SERVICE BULLETIN

APPLICABILITY: 2013MY BRZ with FA Engine **NUMBER:** 02-136-12R
SUBJECT: Oil Seepage Diagnosis and Repair Procedures **DATE:** 09/26/12
REVISED: 10/02/12

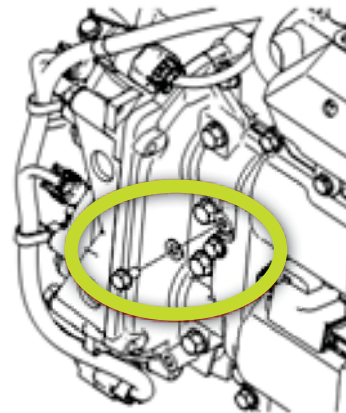
There are four areas that should be closely inspected if an oil leak is reported by the customer:

1. The 6mm tapped hole casting boss area in the left-hand camshaft cap
2. The sealing surfaces between the cylinder head and camshaft carrier
3. The sealing surface between the upper oil pan and the engine block
4. The sealing surfaces of the front timing chain cover

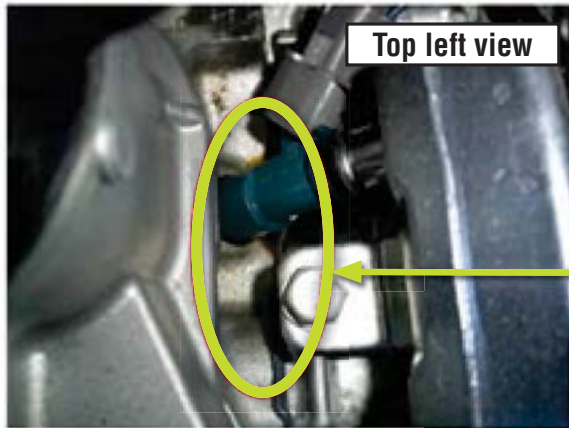
If oil seepage is verified coming from the 6mm threaded hole in the left-hand camshaft cap, install the specified bolt and flat washer.

Bolt: Part# 800206180

Washer: Part# 031106000

Tightening Torque: 6.4 +/- 0.5 Nm
(57 +/- 4 inch-pounds)

Cam carrier seepage seen from top left and lower right side of engine

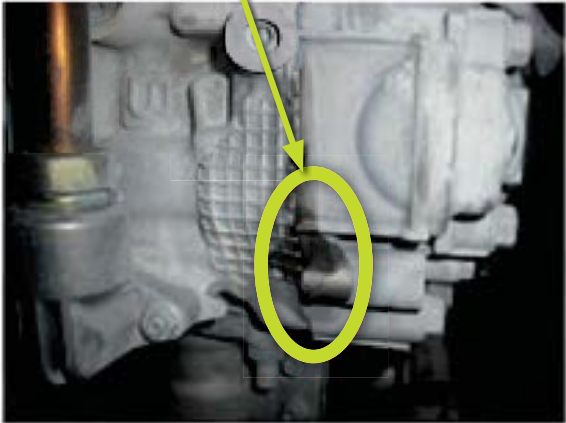
If oil seepage is verified coming from between the cam carrier and the cylinder head as shown in the photos below, remove the cam carrier. Clean the machined sealing surfaces thoroughly and then re-seal using Liquid Gasket ThreeBond 1280B (Part No. SOA5499100) or equivalent*. As shown in the photos below, the o-rings between the cam carrier and the cylinder head will need to be replaced as they are not re-usable. This would also be a good time to clean the Active Valve Control System (AVCS) filter screens which are contained in the cam carriers and shown in the photos below. **NOTE:** The filter screens are one-time use and must be replaced if they need to be removed. The replacement filter part # is 14451 AA 050.

One-time use cam carrier o-rings which must be replaced.

AVCS filter screens must be replaced if removed.

These photos show areas of seepage coming from the upper oil pan to engine block sealing surfaces.

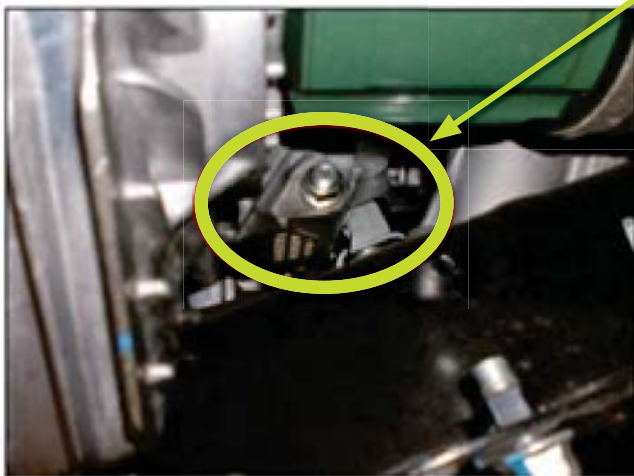
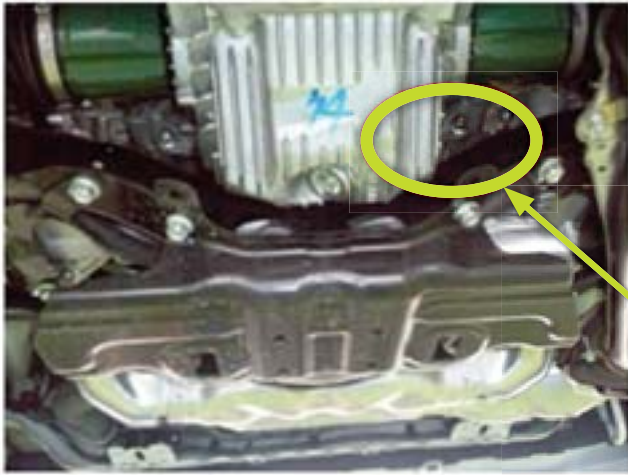
If you find oil seepage between the cylinder block and upper oil pan, remove the upper oil pan, clean the machined sealing surfaces thoroughly and then re-seal using Liquid Gasket ThreeBond 1280B (Part No. SOA5499100) or equivalent*. In addition, the o-rings between the upper oil pan and the cylinder block along with those between the upper and lower oil pan will need to be replaced as they are also one-time use items.

Front Timing Chain Cover resealing procedures:

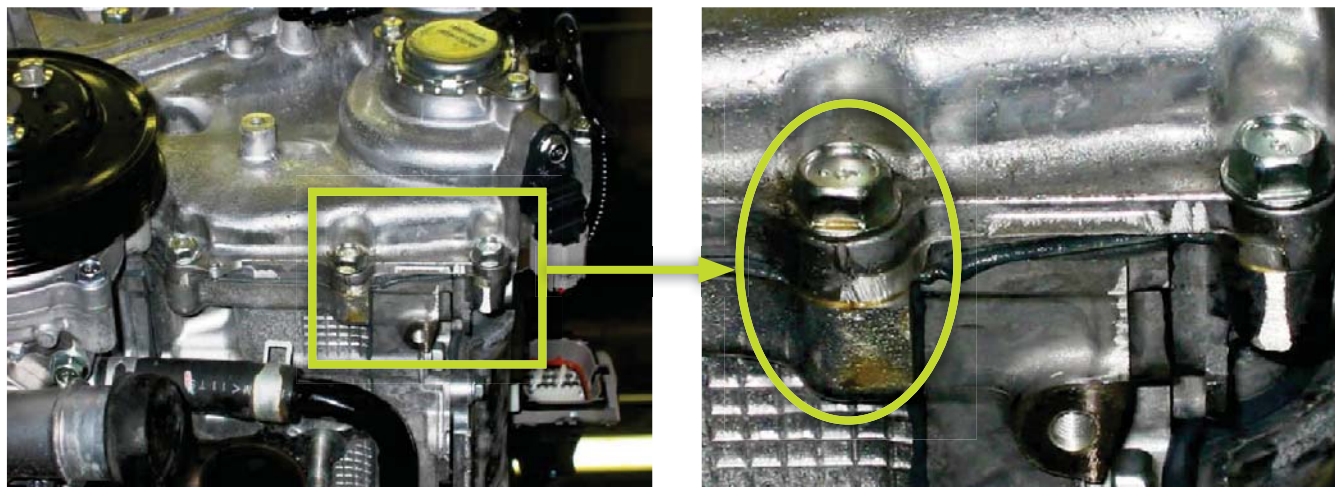
NOTE: Only reseal the front chain cover **AFTER** confirming there is no oil seepage coming from the either cam retainer cap (area 1) and / or the cam carrier (area 3) as previously described.

1. If there are no oil droplets found on the engine under-cover or the lower radiator hose, thoroughly clean the chain cover sealing area along with the surrounding cylinder head and crankcase areas. Re-check for oil seepage again at the next service interval.
2. If the front chain cover is leaking and needs to be resealed, follow the repair procedure in the applicable Service Manual. Thoroughly clean and inspect the sealing surfaces then re-seal using Liquid Gasket ThreeBond 1280B (Part No. SOA5499100) or equivalent*.
